**RFP Title: BUILDING RENOVATIONS & HVAC INSTALLATION AT RWP GATEWAY GARAGE**

**Addendum #: 3**

**Issue Date: 12/18/2025**

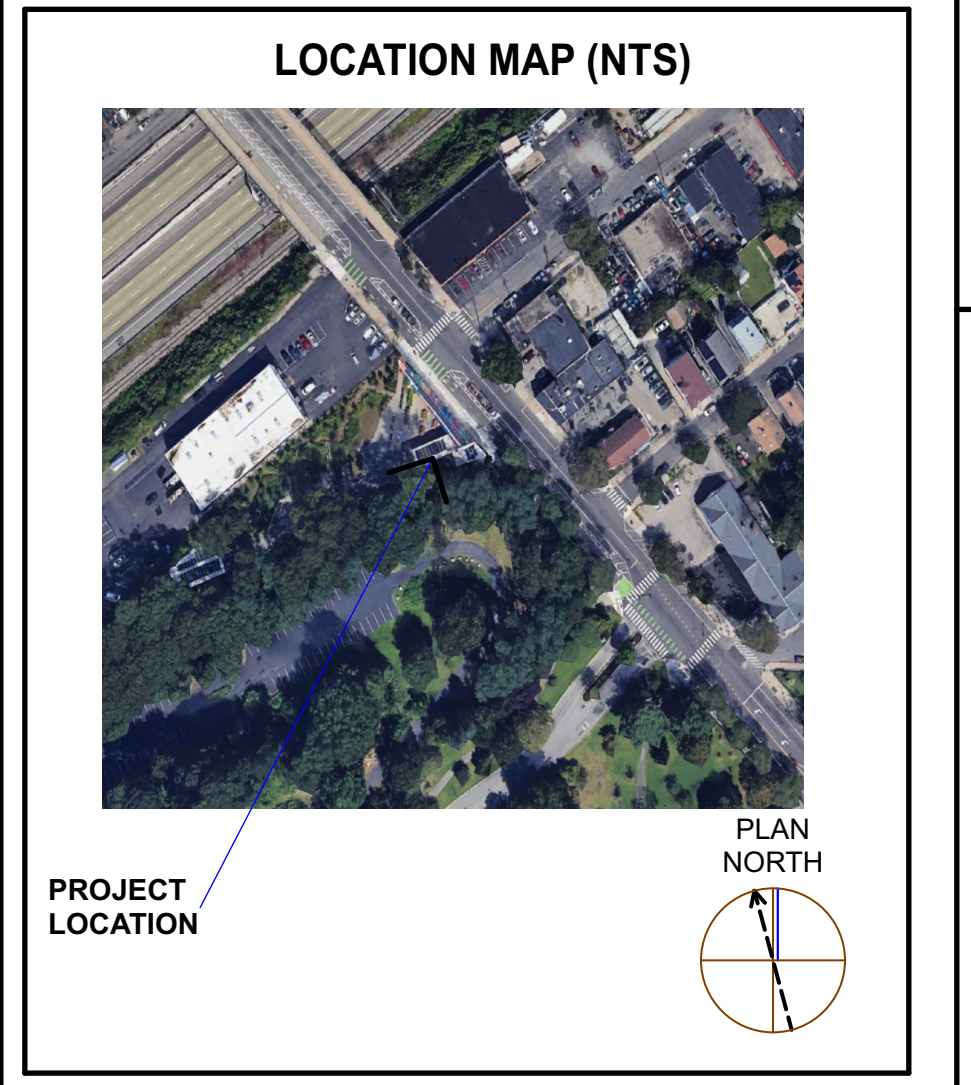
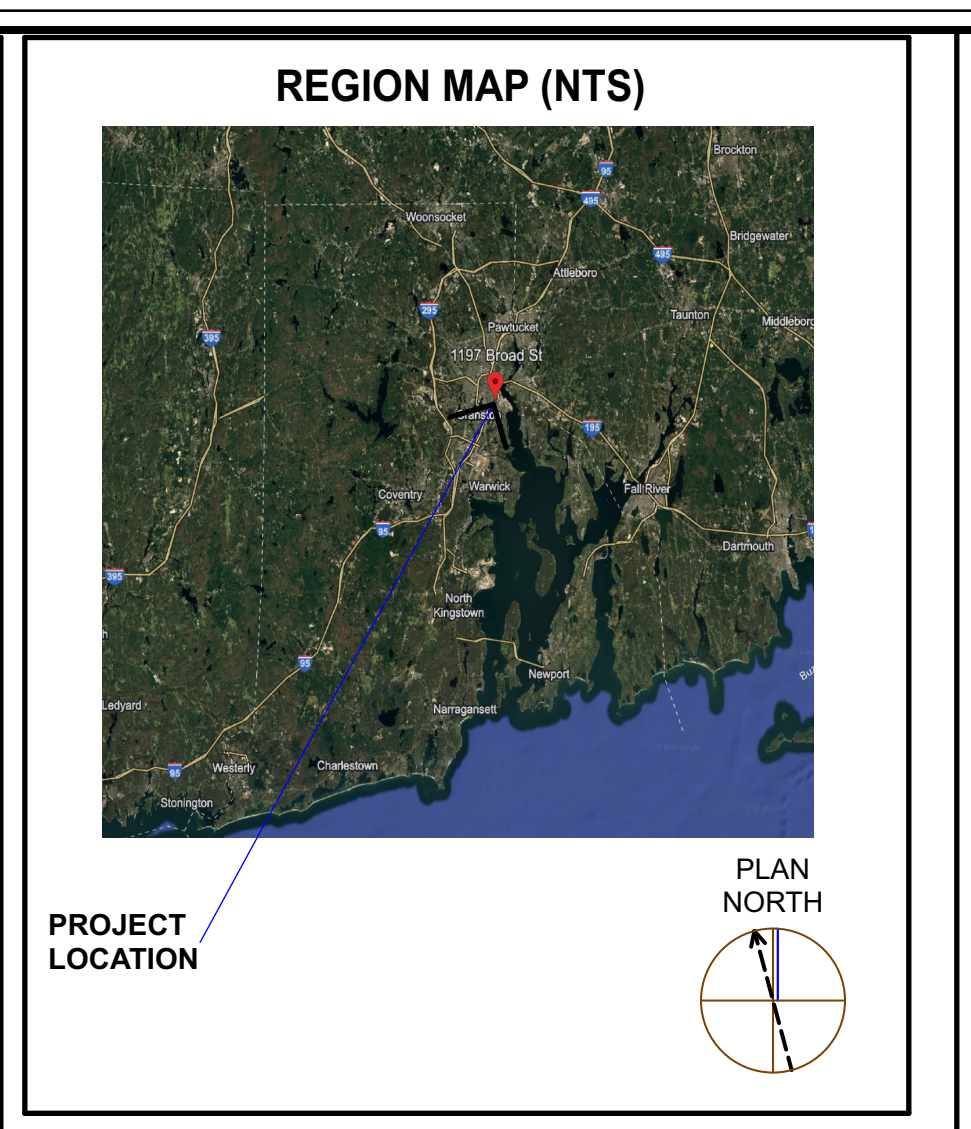
- 9. Q: Has the owner verified that the existing electrical service could support an upgrade to a 200A main circuit breaker? Should the contractor assume the existing panel is capable of a 200A circuit breaker and not include any additional costs to upgrading the existing panel?**

*A: Yes, it is rated for 225A, no upgrades to the panel are needed. (see attached photo)*

**A3 A-114** 1st FLOOR RCP  
SCALE: 1/4" = 1'-0"

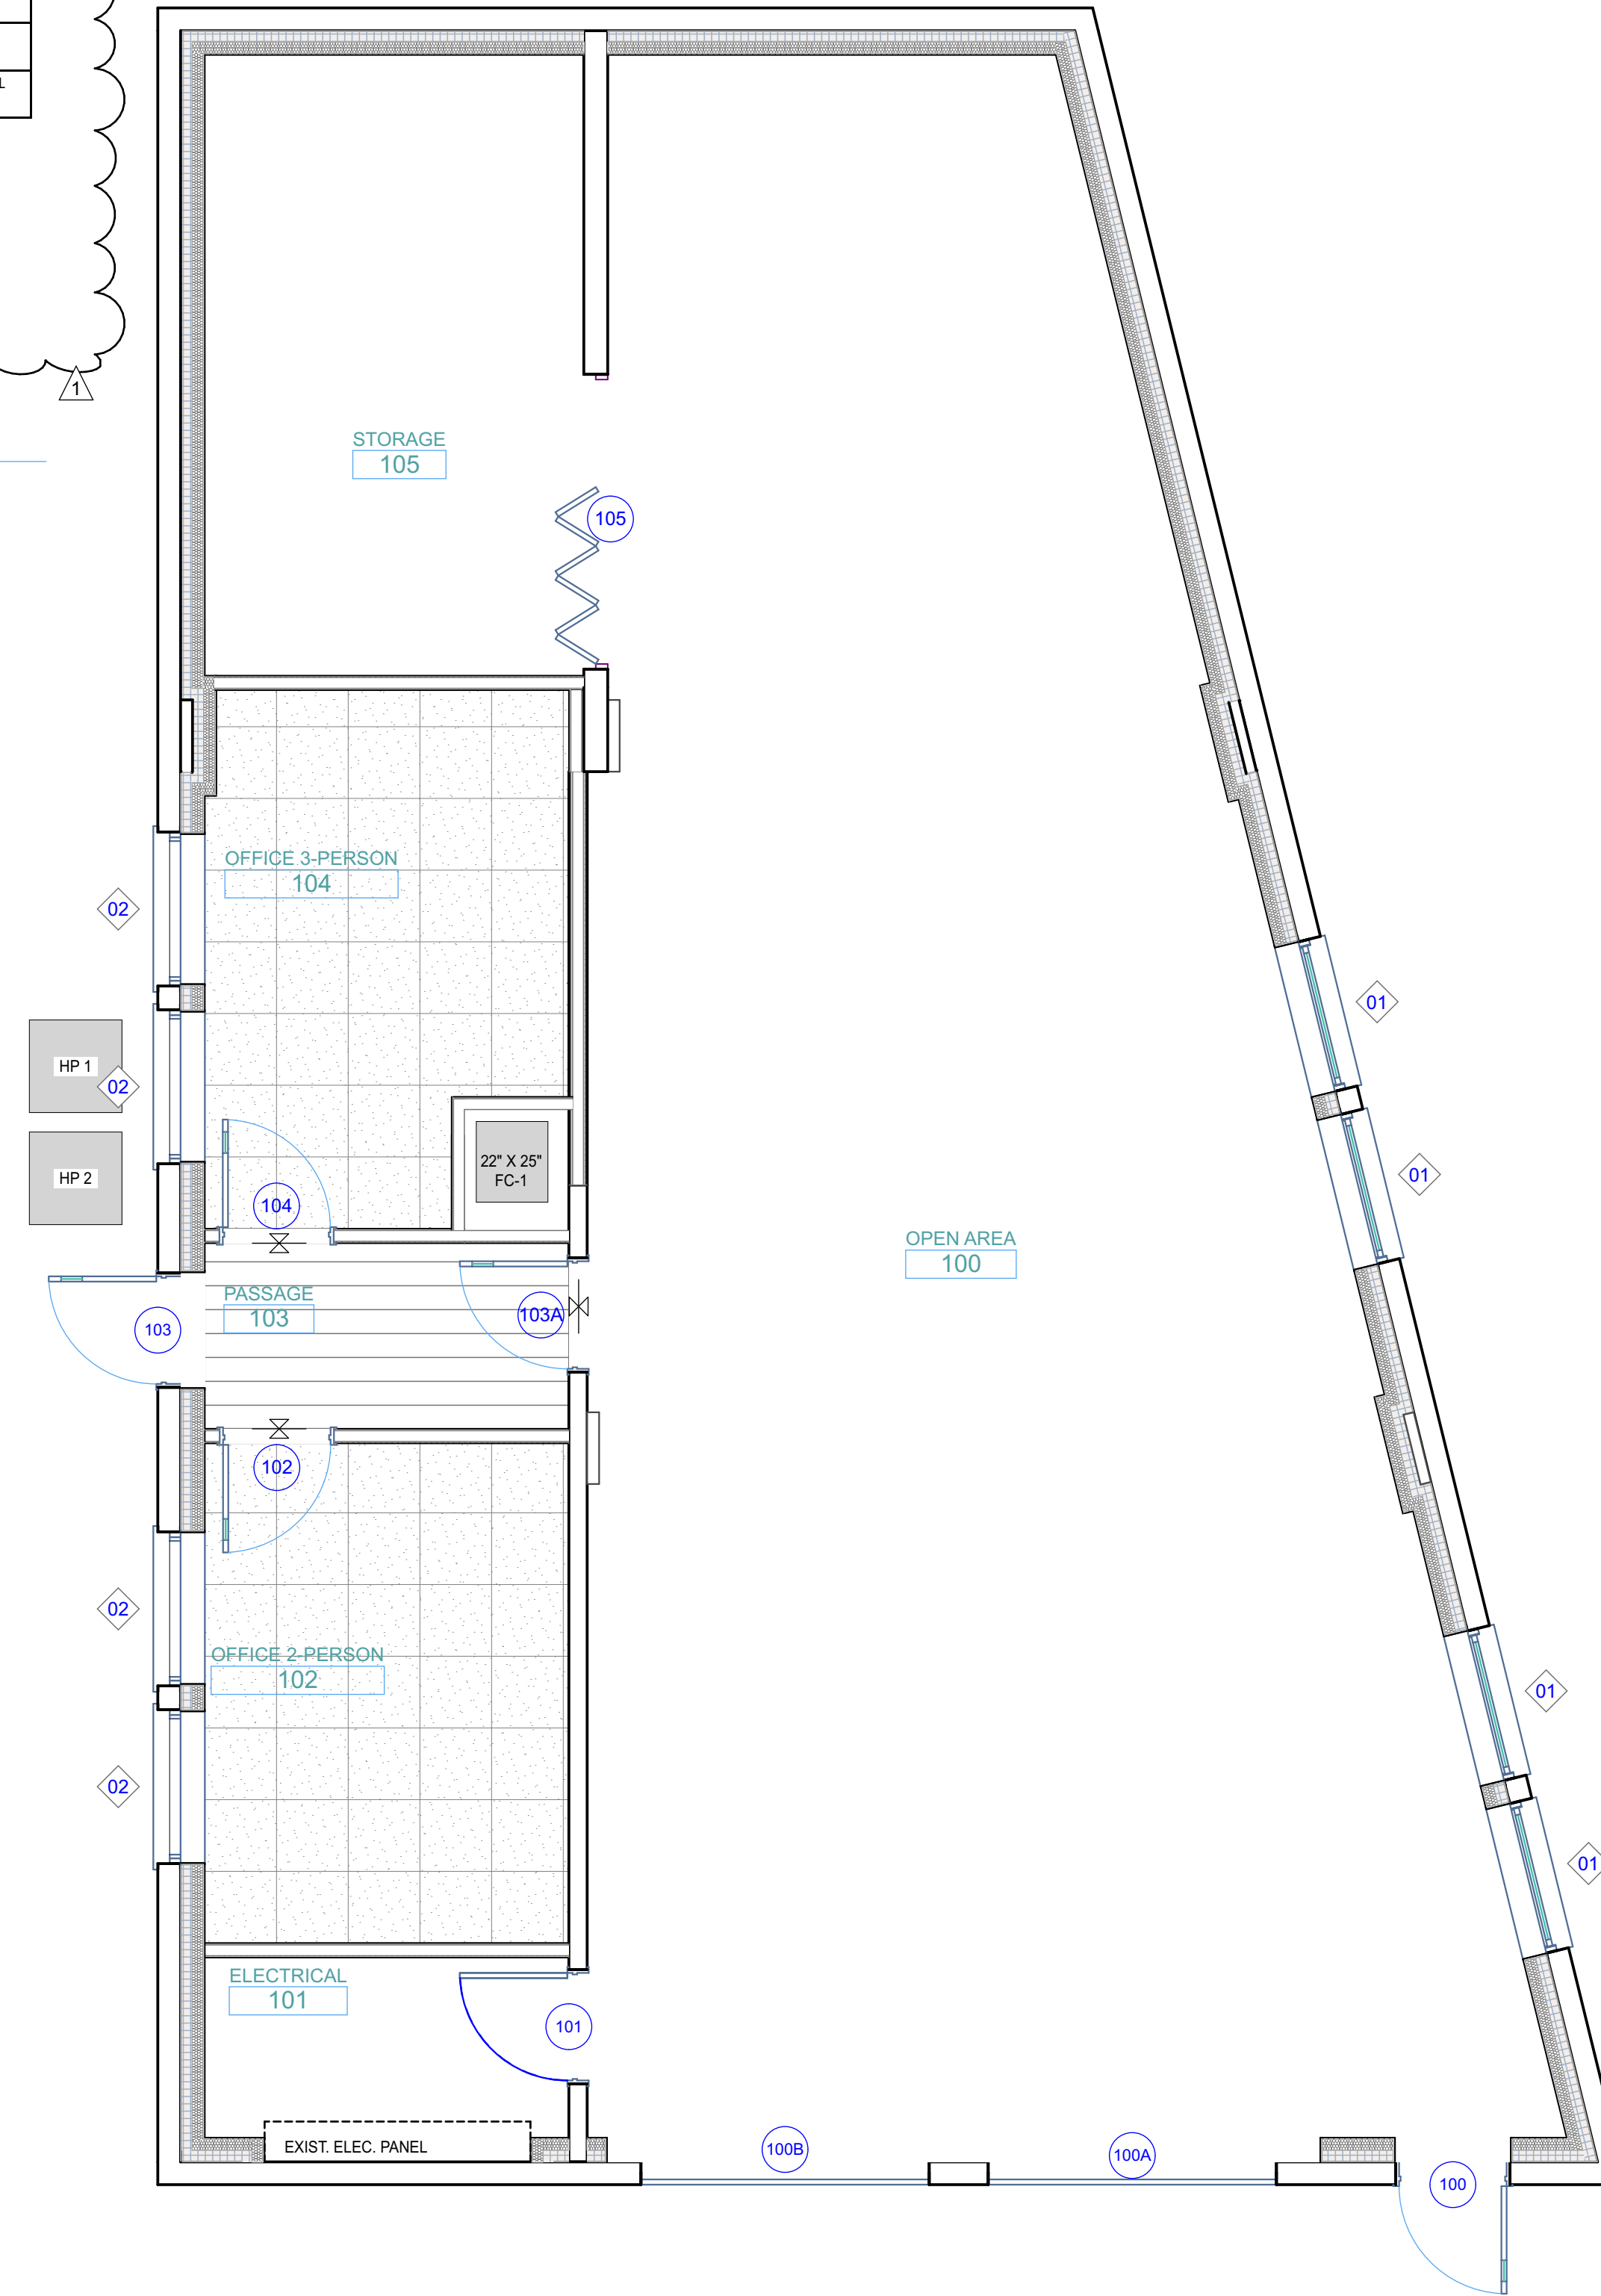
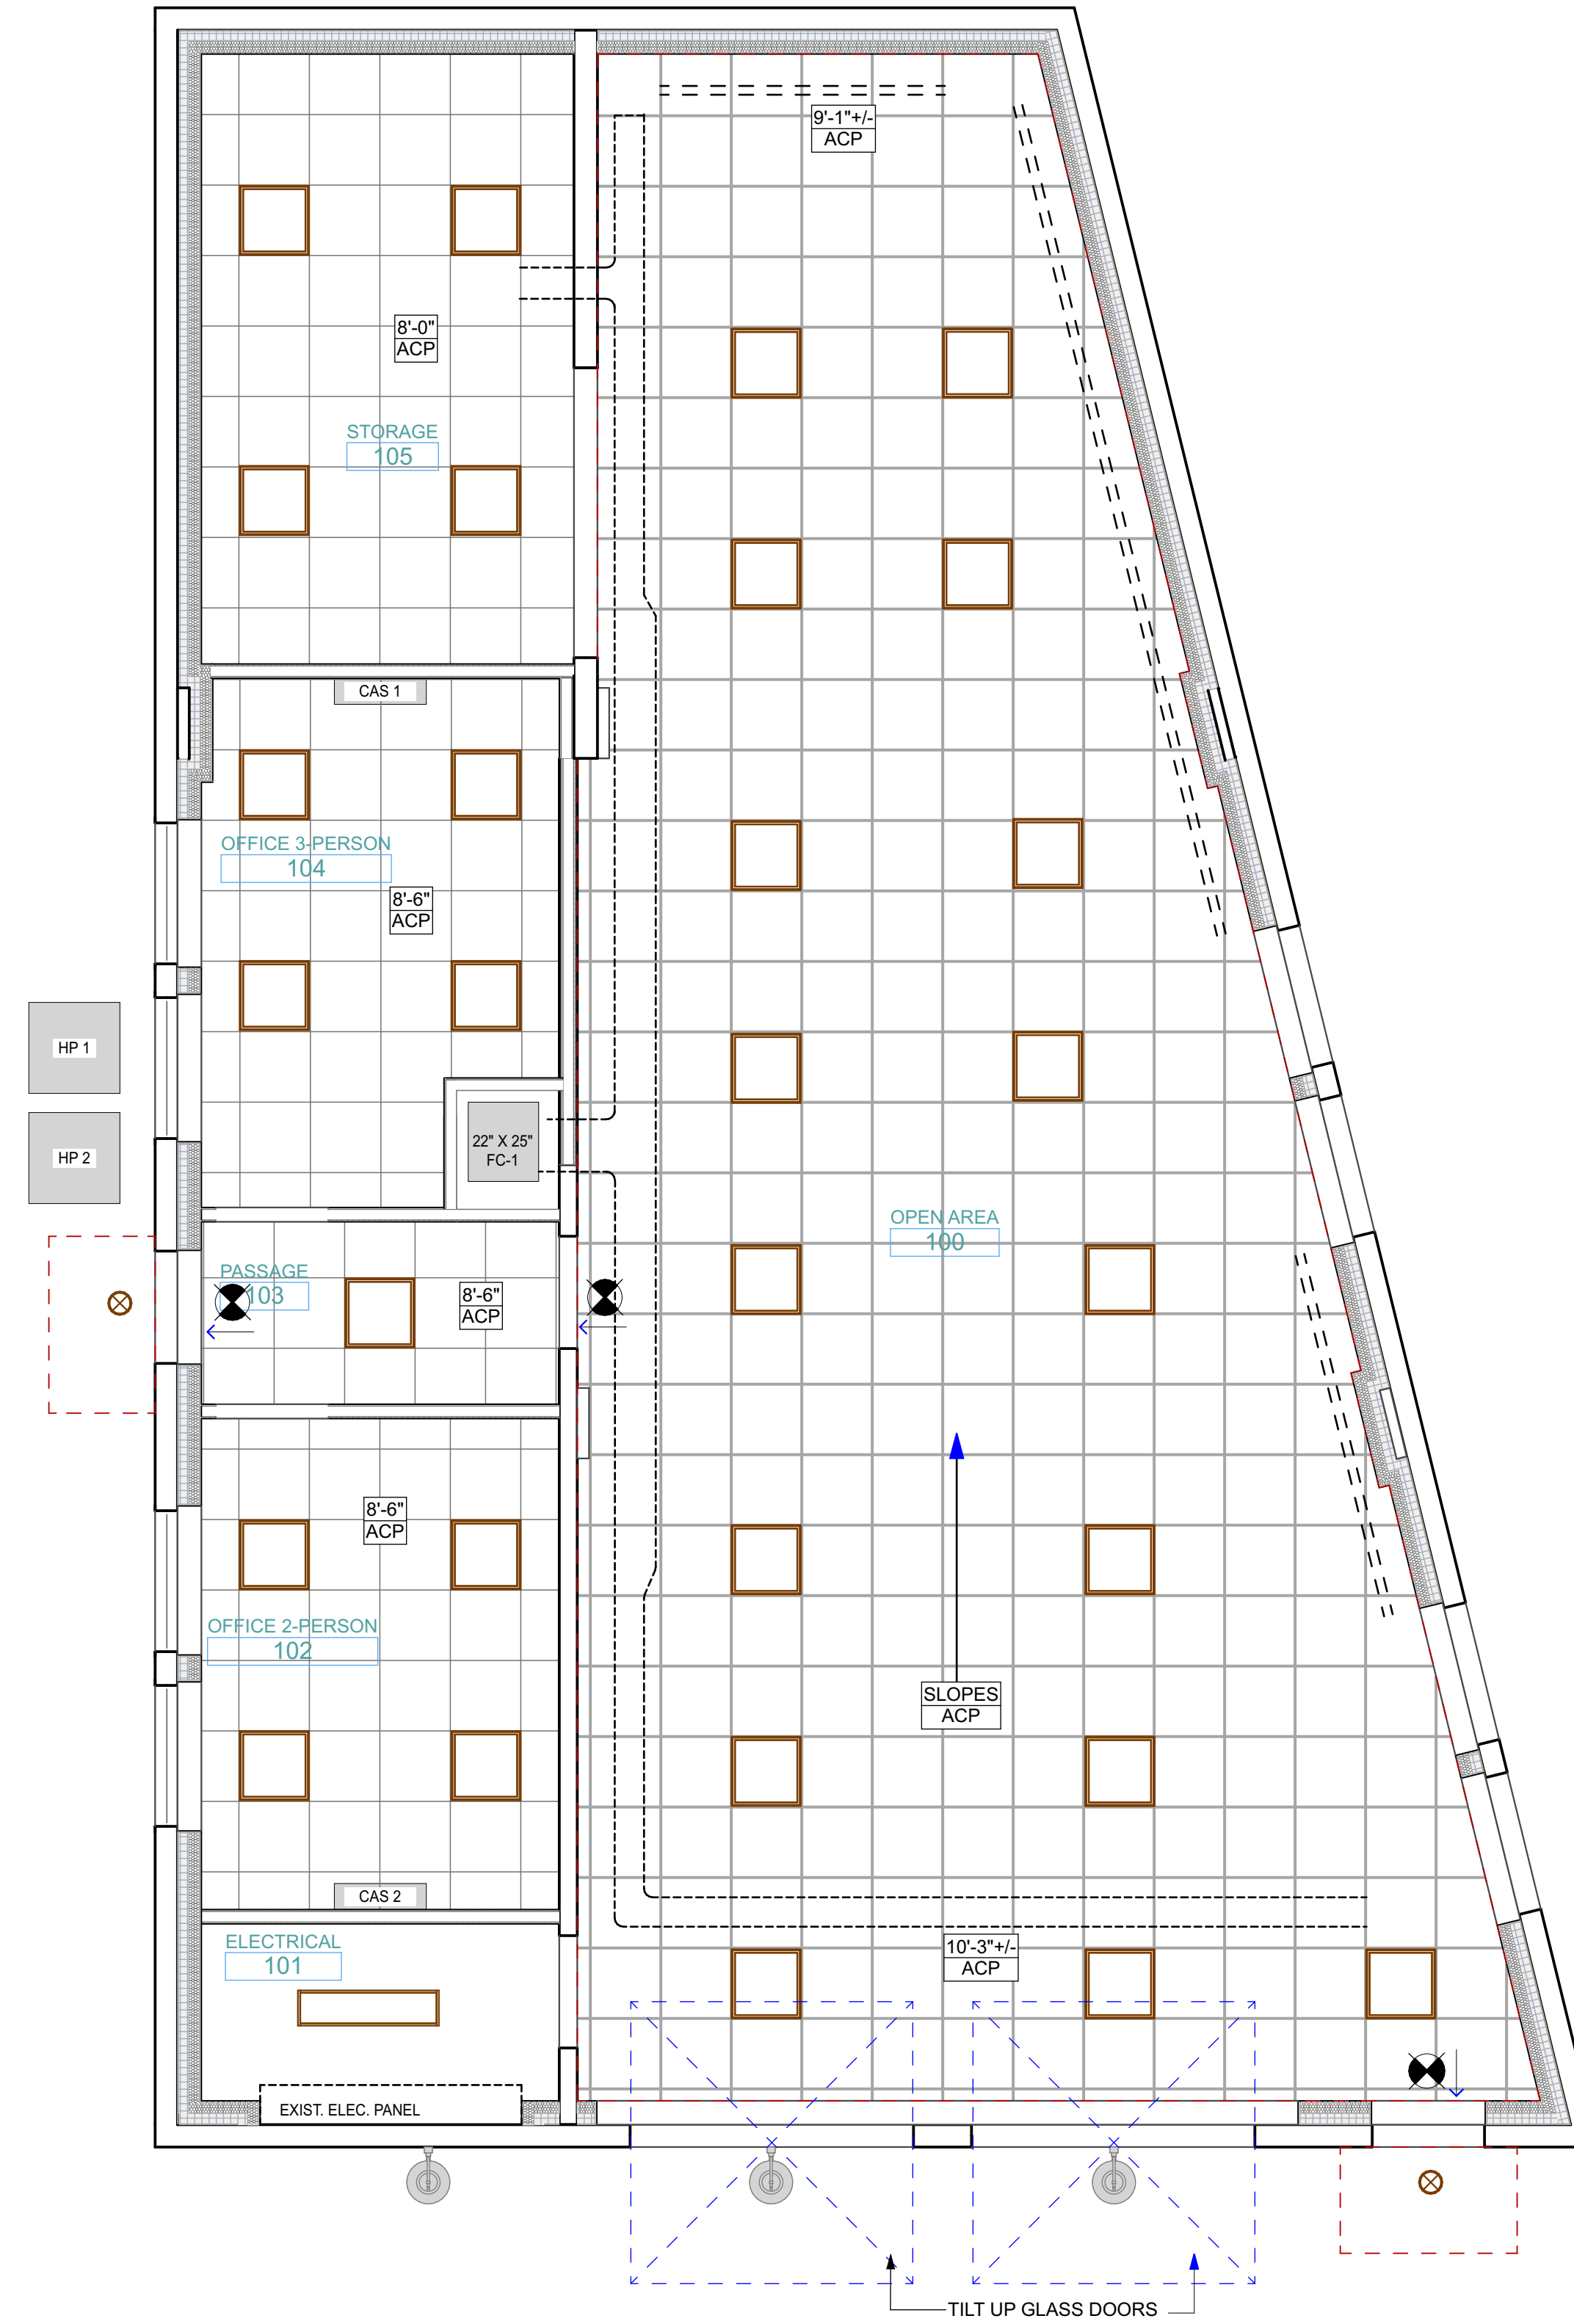
- 7. Q: Is the ceiling required to receive gypsum board fireproofing? Note A-114 mentions gypsum fireproofing under reflected ceiling notes, but no locations are indicated on the drawings. Please clarify.**

*A: No, the ceiling only receives Closed Cell Spray Foam Ceiling Insulation R-49.*
